WordPerfect Document Compare Summary

Revised document: @PFDesktop\MyComputer\X:\Western Fuels Nucla\Permit Revision 2009\Adequacy Response #1\Final Files\2.05.6(3)ProtectionHydrologicBalance 28JUN10 DRAFT.wpd

Section 2.05.6(3)
Protection of the Hydrologic Balance

Figure 2.05.6(3)-1

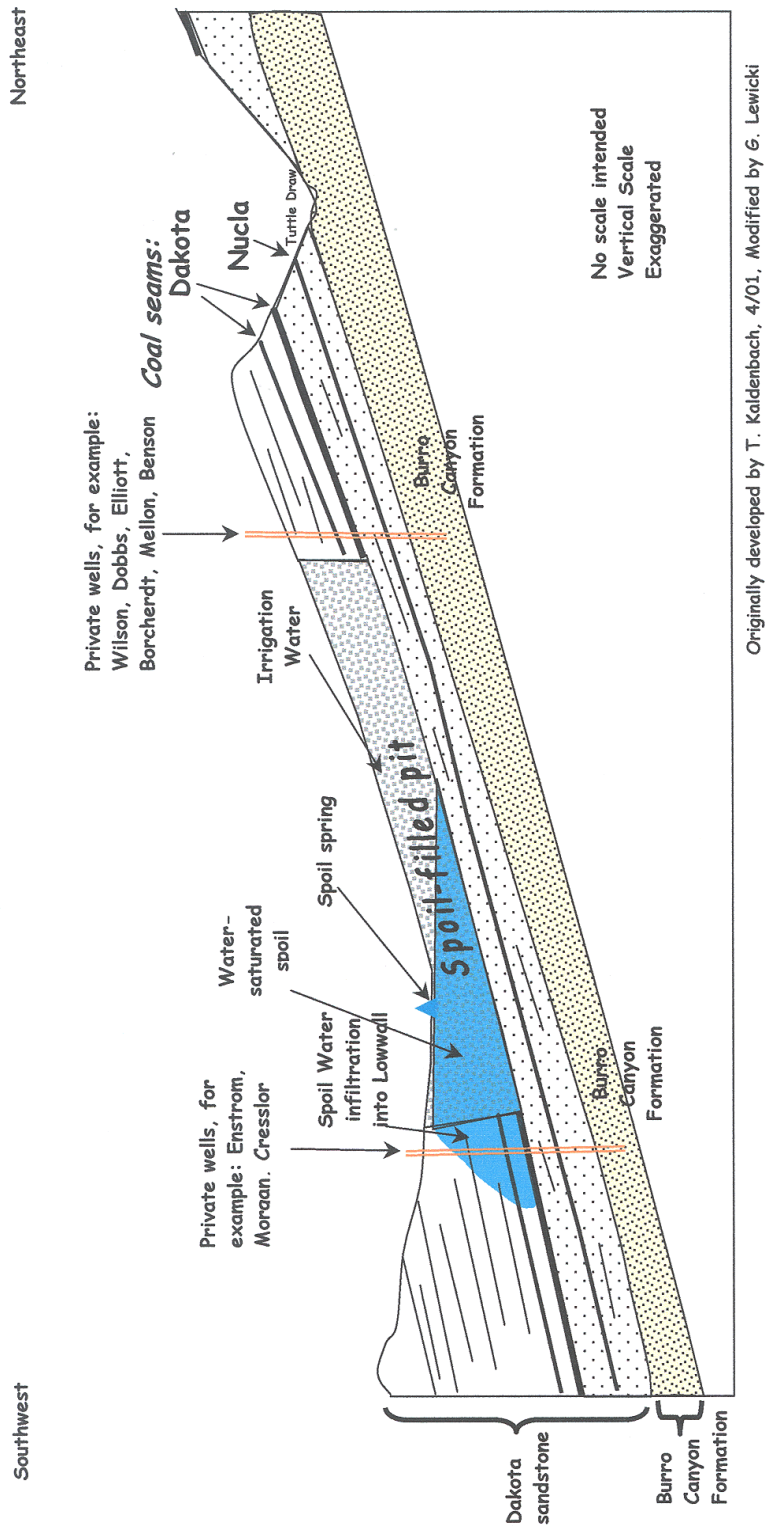
Figure 2.05.6(3)-1 shows a general cross-section downgradient through the New Horizon #2 mine spoil.

Figure 2.05.6(3)-1 shows how infiltration will build up in the spoil downgradient and begin to seep into the lowwall. This spoil water may enter one or more of the minor sandstone beds of the overburden (Dakota Sandstone). This annual infiltration is calculated below, assuming a 10' thick somewhat permeable bed in the lowwall strata:
